Re: St. Lucie Unit 1
Docket No. 50-335
Inservice Inspection Plan
Fourth Ten-Year Interval Unit 1 Relief Request No. 8, Revision 0

RESPONSE TO REQUEST FOR ADDITIONAL INFORMATION (RAI)

RELIEF REQUEST NO. 8 INSPECTION OF REACTOR VESSEL

(TAC NO. MF4490)

Figure 14. Plot of da/dt versus K_I for Alloy 690 Data Produced by ANL and PNNL and Available in Public References, $\leq 20\%$ Cold Work

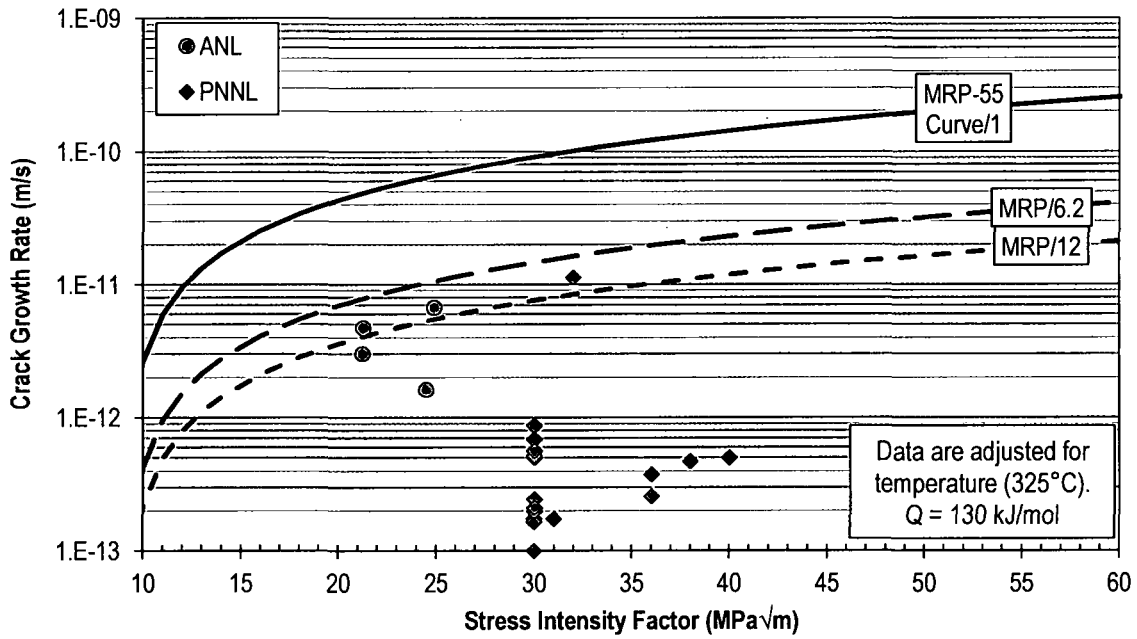
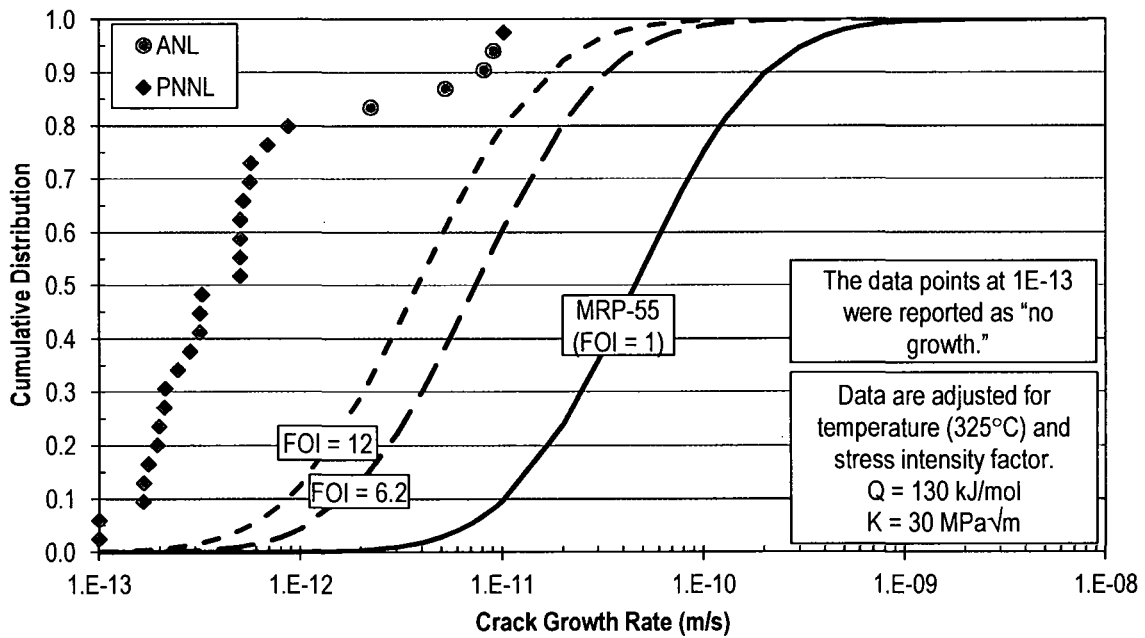
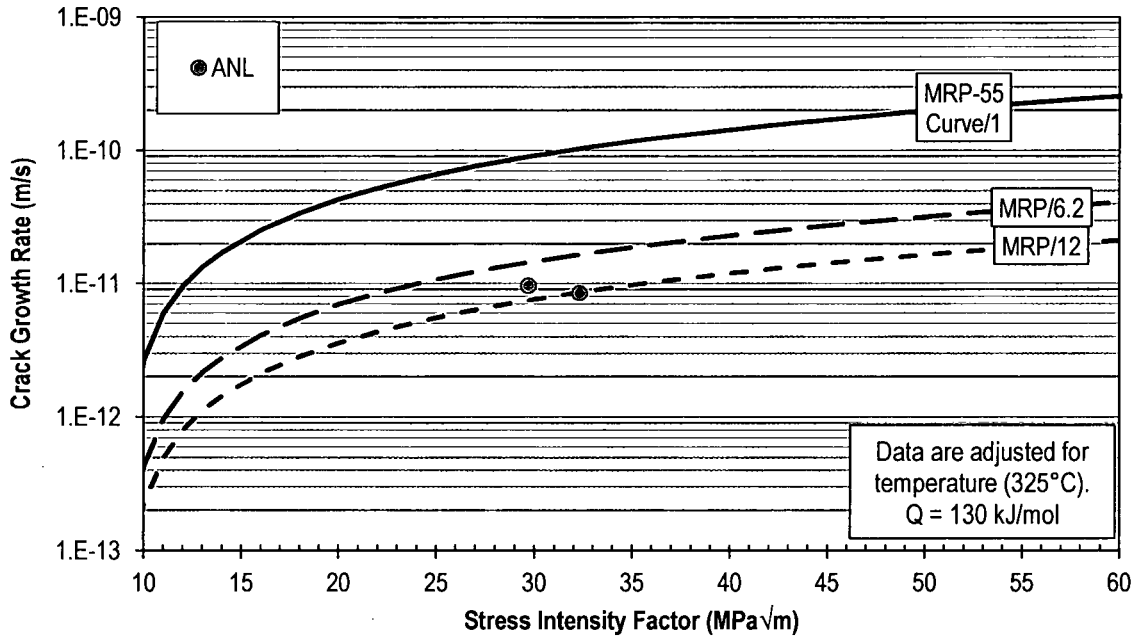
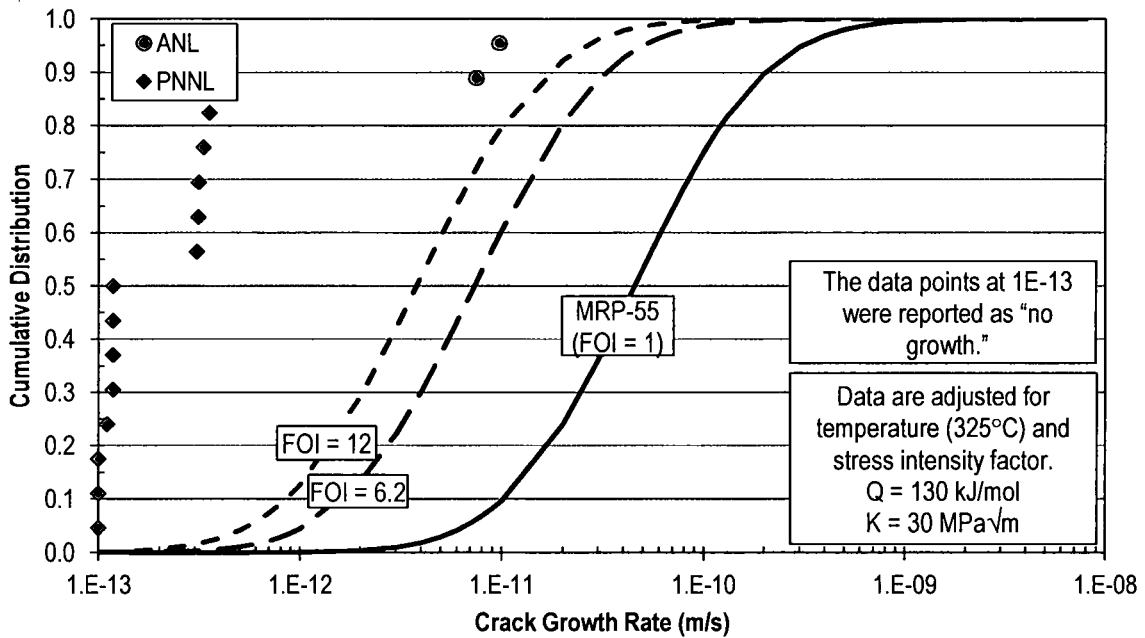
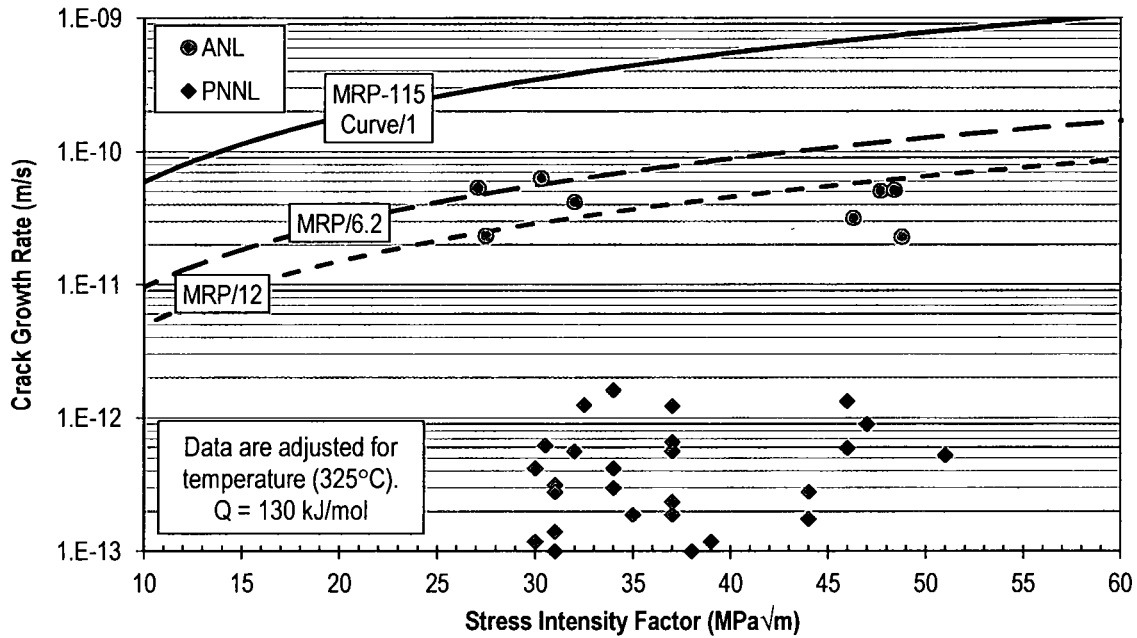
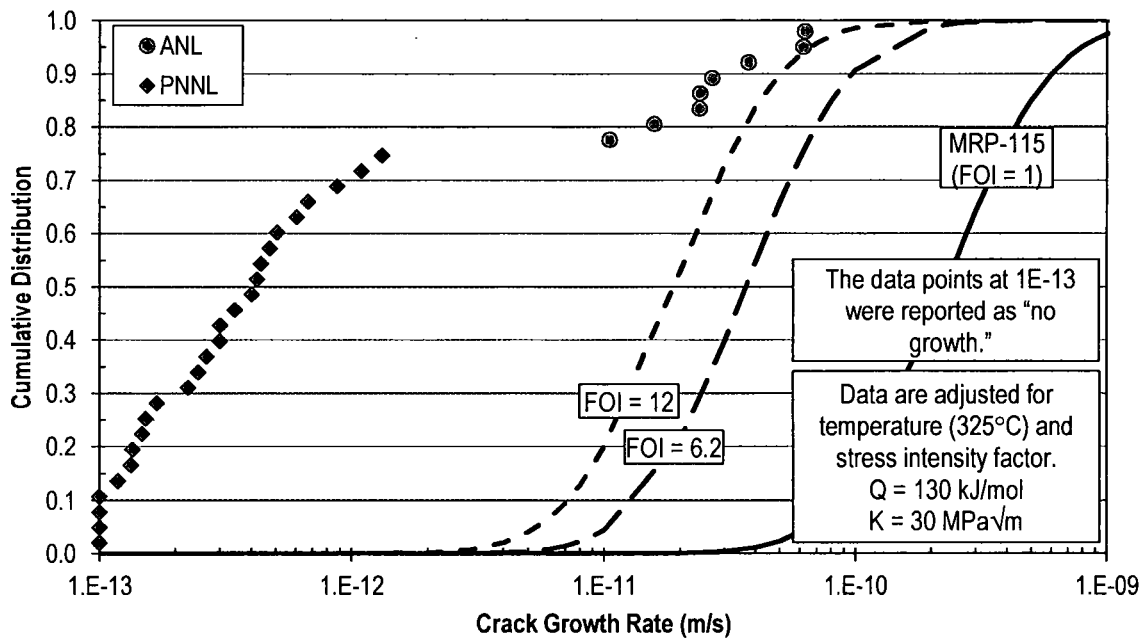
An assessment of the crack growth rate data points particular to data generated by ANL and PNNL is presented in Figure 14 through Figure 19, including data with up to 20% cold work. The data shown are specifically those data that have been openly published, representing the large majority of the data from ANL and PNNL in MRP-375. Since only two constant load Alloy 690 HAZ points have been openly published, the cumulative distribution of Figure 17 also includes data that have not been openly published. The data for ANL and PNNL are shown separately considering that U.S. NRC is most familiar with the testing performed at these two national laboratories. Only 2 of the total of 94 data points from ANL and PNNL are within a factor of 6.2 below the deterministic MRP-55 and MRP-115 lines.

Figure 20. Plot of da/dt versus K_I for Alloy 690 Data from All Laboratories, > 10 & $\leq 20\%$ Cold Work, CRDM and Bar Material, Constant Load or K_I Testing

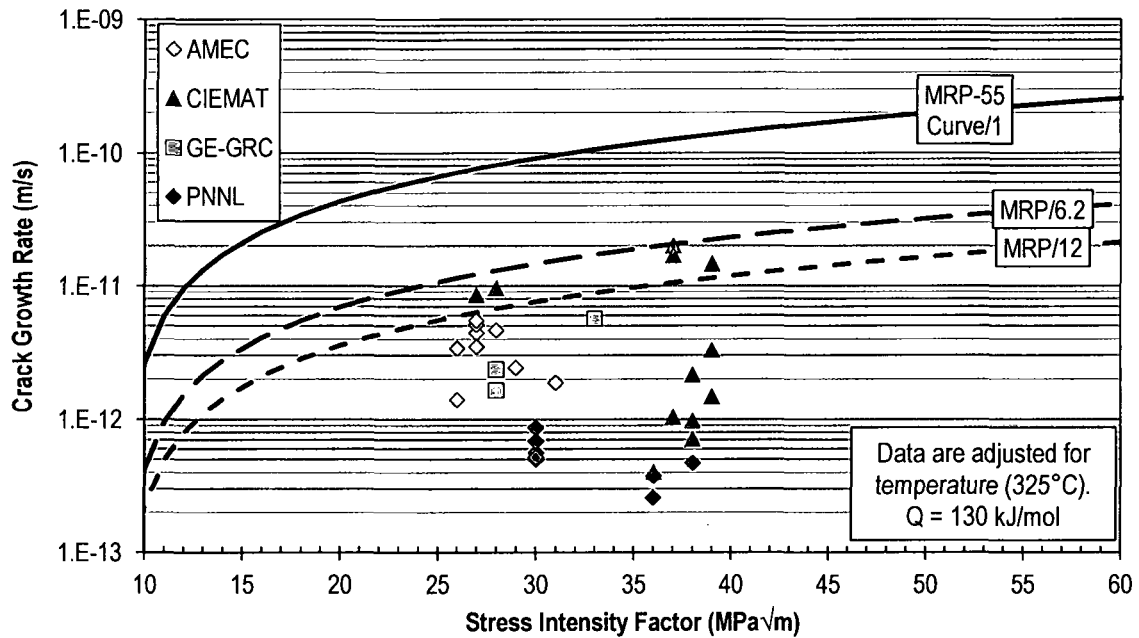
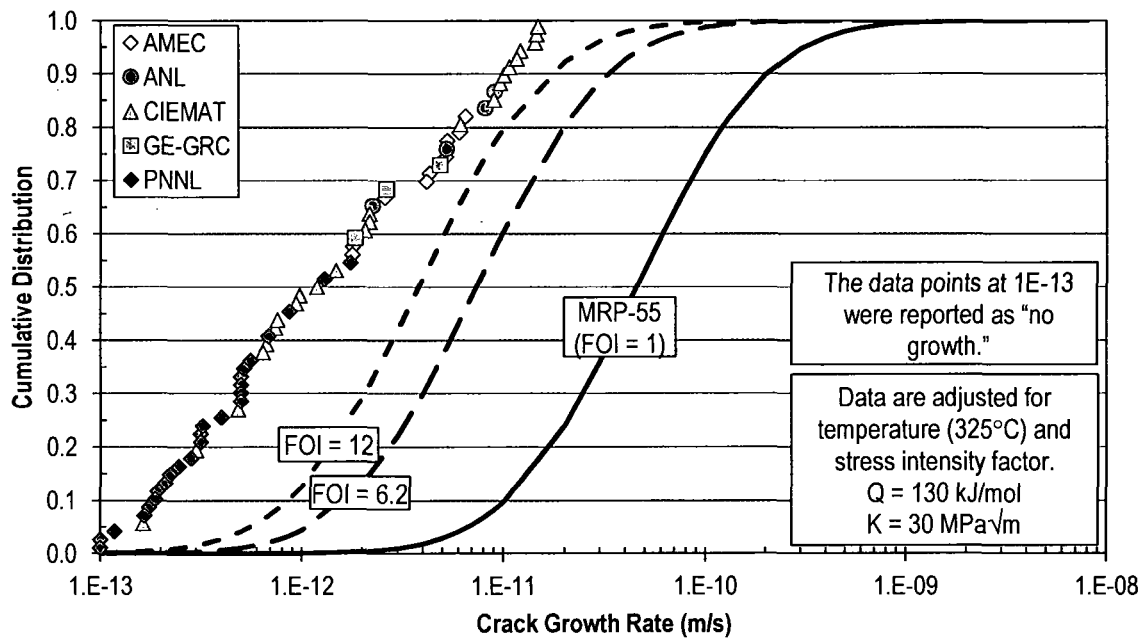
An assessment of the crack growth rate data points for Alloy 690 CRDM nozzle and bar material product forms for cold work levels up to 20% is presented in Figure 20 and Figure 21. Equivalent plots for Alloy 52/152 material for the purpose of including the limited number (i.e., five) of weld metal data points generated for added cold work conditions are shown in Figure 22 and Figure 23. Added cold work for weld metals is not directly relevant to plant material conditions.

Figure 22. Plot of da/dt versus K_I for Alloy 52/152 Data from All Laboratories, > 10 & $\leq 20\%$ Cold Work, Constant Load or K_I

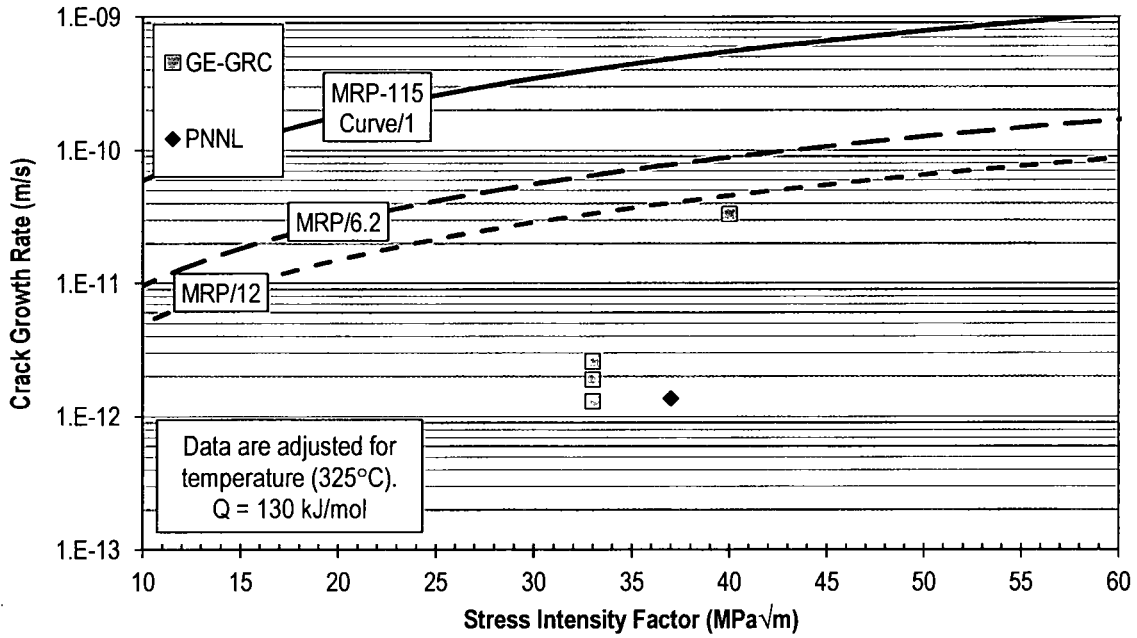
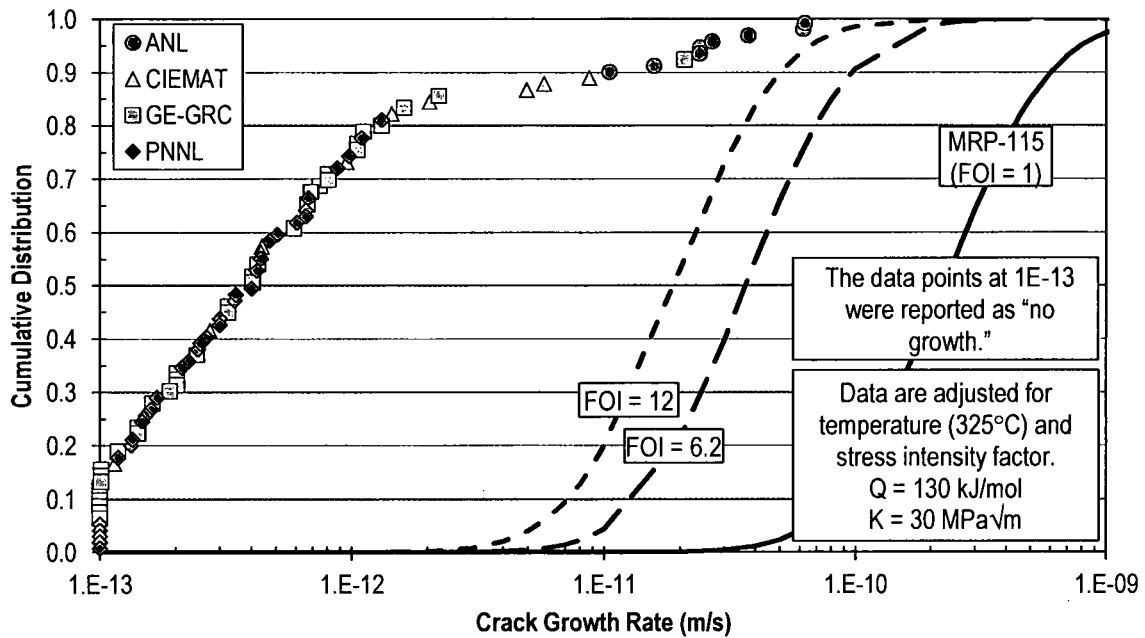
For Alloy 690 control rod drive mechanism (CRDM) / control element drive mechanism (CEDM) nozzles and other RV head penetration nozzles, the effective cold-work level in the bulk Alloy 690 base metal is expected to be no greater than roughly 10%. This is based on fabrication practices specific to replacement heads, i.e., material processing and subsequent nozzle installation via welding [7]. Furthermore, the crack growth rate data presented for Alloy 600 in MRP-55 do not include cases of added cold work. Comparing cold worked Alloy 690 data against non-cold worked Alloy 600 data results in a conservatism in the factor of improvement for Alloy 690 material as the cold worked material condition for Alloy 600 would be expected to result in a somewhat increased deterministic crack growth rate for Alloy 600, and thus a greater apparent factor of improvement. Nevertheless, the assessment in Figure 20 through Figure 23 is included in this document to illustrate the effect of higher levels of cold work. These data

Figure 24. Plot of da/dt versus K_I for Alloy 690 Data from Heat WP142

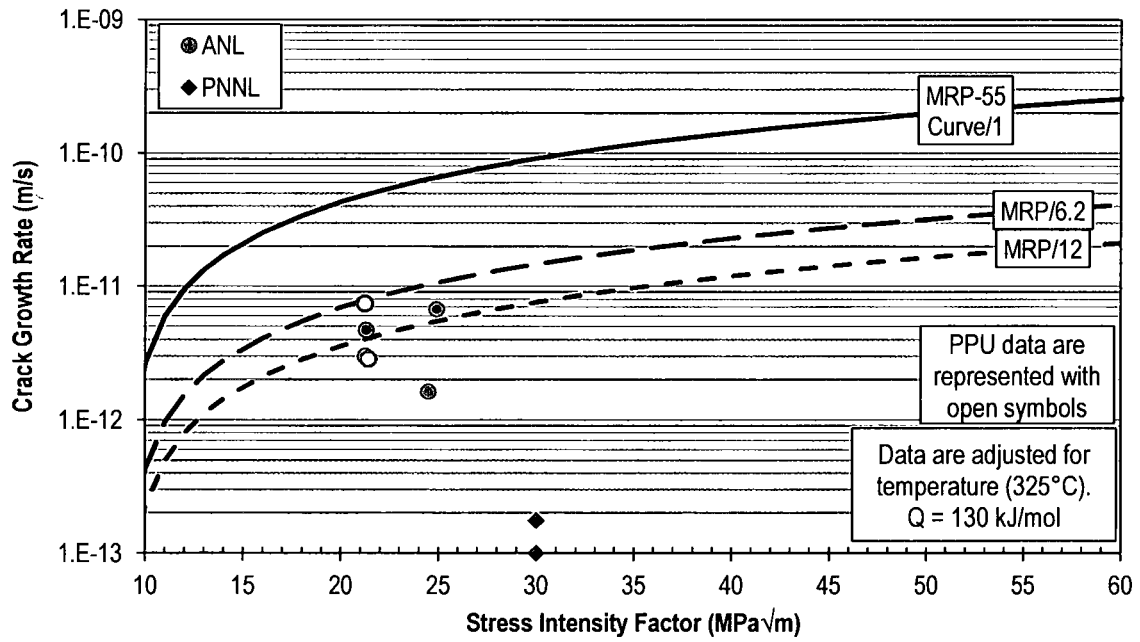
- In some cases, different laboratories have reported large differences in crack growth rate for the same material heat or test weld. This behavior is illustrated in Figure 6 for the Alloy 152 heat WC04F6 and Figure 24 for the Alloy 690 heat WP142. Thus, individual data points showing relatively high crack growth rates might not reflect the true susceptibility of particular categories of nozzle or weld material. Consistent data from multiple laboratories may be needed before one can conclude that a particular category of nozzle or weld material has an elevated susceptibility to PWSCC growth.
